Appendix D – Iconic Oil Palm Response (Pure Projects)

Fairmont Port Douglas – RFI Response

DA Reference : MCUI 2020_3711/1

Item 7 :

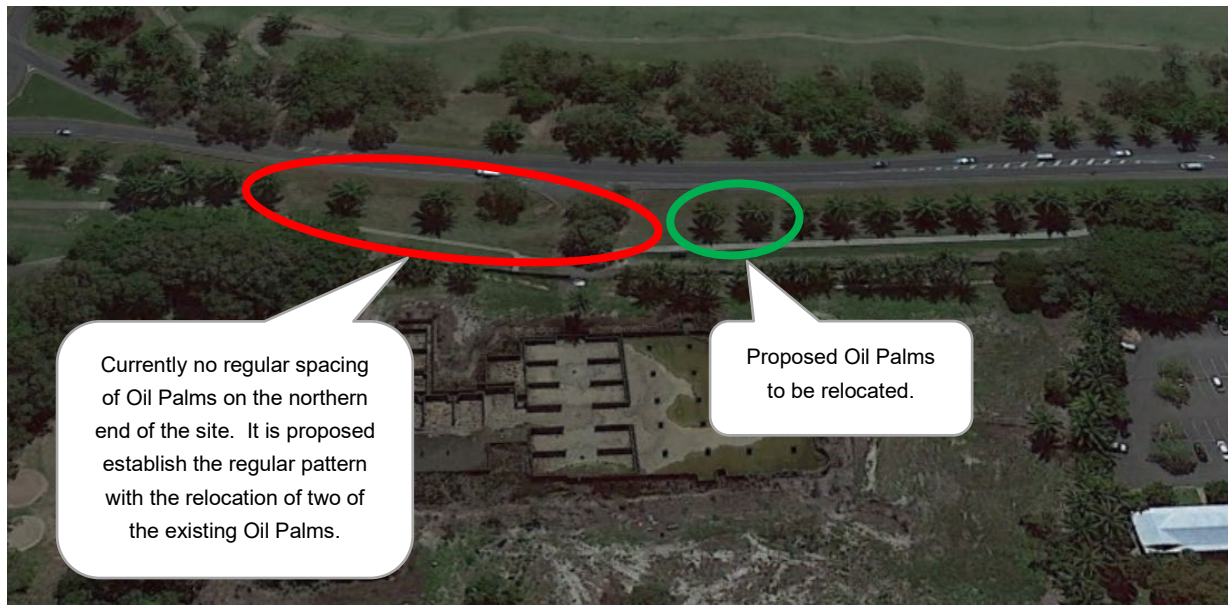
The proposal includes to remove at least three iconic Oil Palms for the construction of the main access to the site. This conflicts with the purpose of the Port Douglas and Craiglie Local Plan Code as the iconic Oil Palms are required to be retained. Amend the access design and demonstrate how the iconic Oil Palms can be retained.

We have reviewed the location of the Oil Palms in relation to the driveway crossover and based on the analysis we can not fit the driveway between two pairs of Oli Palms without potentially disturbing the root systems, in the Landscape design by Durie Design the effected Oil Palms have been documented to be relocated in a professional manner.

In support of the crossover location GTA our Traffic Consultant have looked at the location of the crossover and the location is the furthest north we can go on the site to allow sufficient distance from the round about for a left turn into the project for guests into the main Porte Cochere as they are heading south on Port Douglas Road.

On review of the Oil Palm layouts we note to Council as per the image below it is clear that the regular spacing of the Oil Palms is not along the full length of the current site.

The proposed relocation of the effected Oil Palms will be located so that the regular spacing continues to the northern end of the site.
